ALERT SERVICE BULLETIN NO. ASB315-63/2

G 103 TWIN II	S/N 3501 – 3729
	S/N 3730 – 3878
	S/N 33879 – 34078
G 103A TWIN II ACRO	S/N 3544 – 34078 (mit Suffix „K“)
G 103C TWIN III ACRO	S/N 34101 – 34203

Limitation of Operation

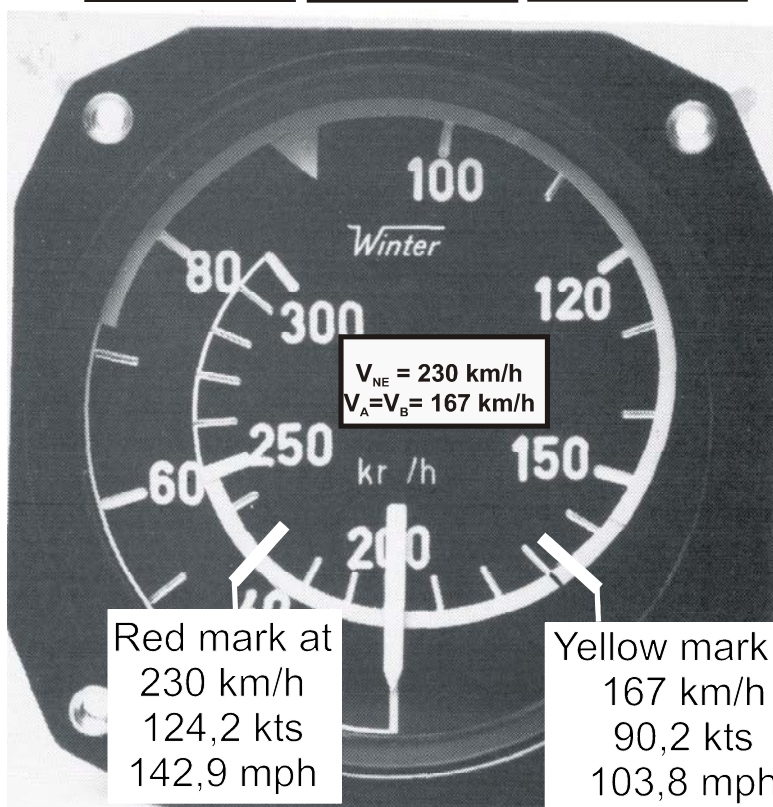
- 1.8.1 Apply on the front and rear airspeed indicator
- a red mark at **230 km/h (124,2 kts, / 142,9 mph)**
 - a yellow mark at **167 km/h (90,2 kts, / 103,8 mph)**

NOTE: The marks are attached to the SB.
